Model	Old design	Changes	New Design
SV-L0814MP		<p><b>C-Mount Material</b> Aluminum → Brass</p> <p><b>External Diameter of Focus Adjustment</b> φ42 → φ43</p> <p><b>External Diameter of Front Lens Rim</b> No changes</p>	
SV-L12514MP		<p><b>C-Mount Material</b> Aluminum → Brass</p> <p><b>External Diameter of Focus Adjustment</b> φ42 → φ43</p> <p><b>External Diameter of Front Lens Rim</b> φ37 → φ38</p>	
SV-L1614MP		<p><b>C-Mount Material</b> Aluminum → Brass</p> <p><b>External Diameter of Focus Adjustment</b> φ42 → φ43</p> <p><b>External Diameter of Front Lens Rim</b> φ37 → φ38</p> <p><b>Other:</b> Mounting section of the lens also has shape design changes</p>	
SV-L2514MP		<p><b>C-Mount Material</b> Aluminum → Brass</p> <p><b>External Diameter of Focus Adjustment</b> φ42 → φ43</p> <p><b>External Diameter of Front Lens Rim</b> φ37 → φ38</p>	
SV-L3514MP		<p><b>C-Mount Material</b> Aluminum → Brass</p> <p><b>External Diameter of Focus Adjustment</b> φ42 → φ43</p> <p><b>External Diameter of Front Lens Rim</b> φ37 → φ38</p>

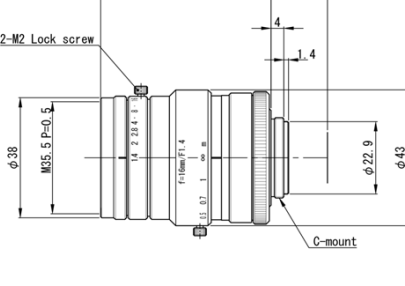
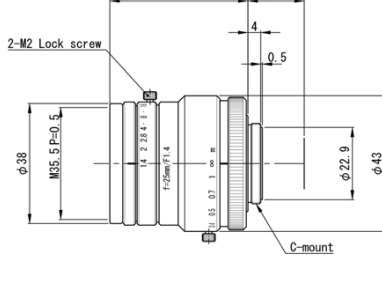
SV-L5014MP		<p><b>C-Mount Material</b> Aluminum → Brass</p> <p><b>External Diameter of Focus Adjustment</b> φ47.5 → φ49</p> <p><b>External Diameter of Front Lens Rim</b> φ42.5 → φ44</p>	
SV-L7528MP		<p><b>C-Mount Material</b> Aluminum → Brass</p> <p><b>External Diameter of Focus Adjustment</b> φ47.5 → φ49</p> <p><b>External Diameter of Front Lens Rim</b> φ48 → φ49</p>
